**ADDENDUM NO. 4
TO
PLANS, SPECIFICATIONS, AND CONTRACT DOCUMENTS
FOR
CITY OF DENTON, TEXAS
IFB 7027-FOR THE CONSTRUCTION OF NORTH BONNIE BRAE STREET AT
SCRIPTURE STREET ROUNDABOUT
April 11, 2019**

PLANS FOR THE CONSTRUCTION OF: PAVING AND DRAINAGE IMPROVEMENTS

AT SCRIPTURE STREET ROUNDABOUT

ED(4) - 14

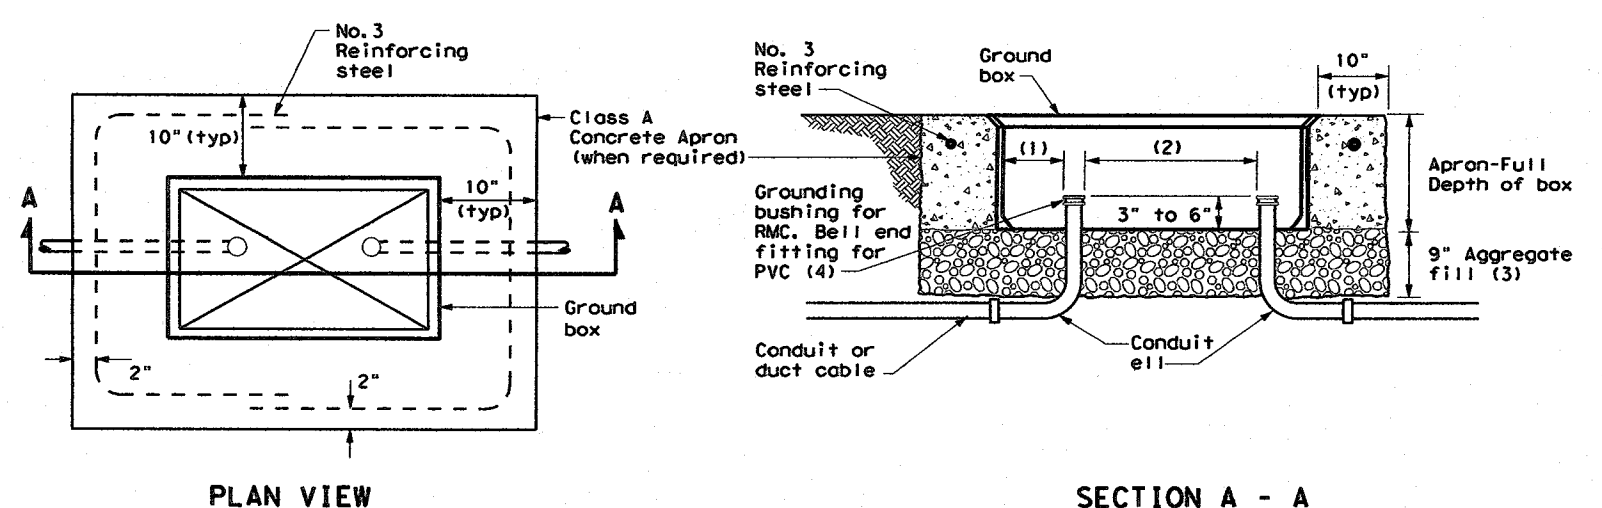
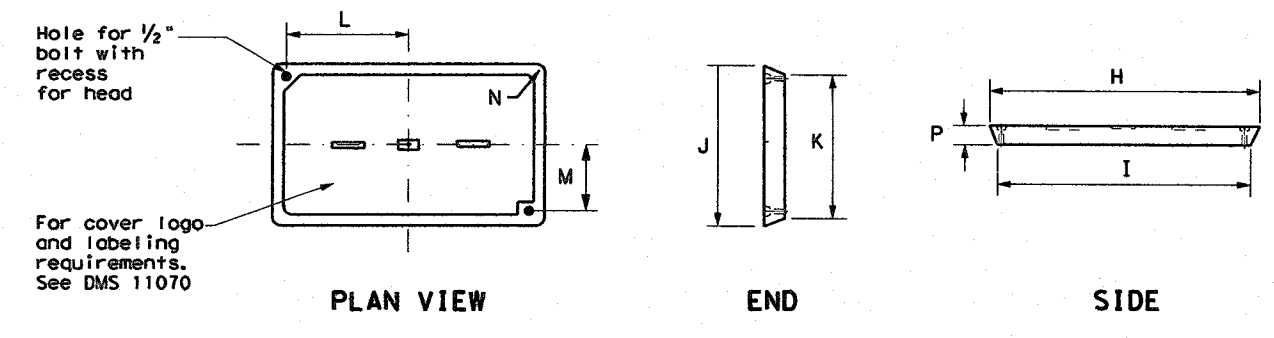
2. What size and type of pull box are they specifying.

Detail sheet 101B was added showing detail ED(4)14 with this addendum for the Type A ground box.
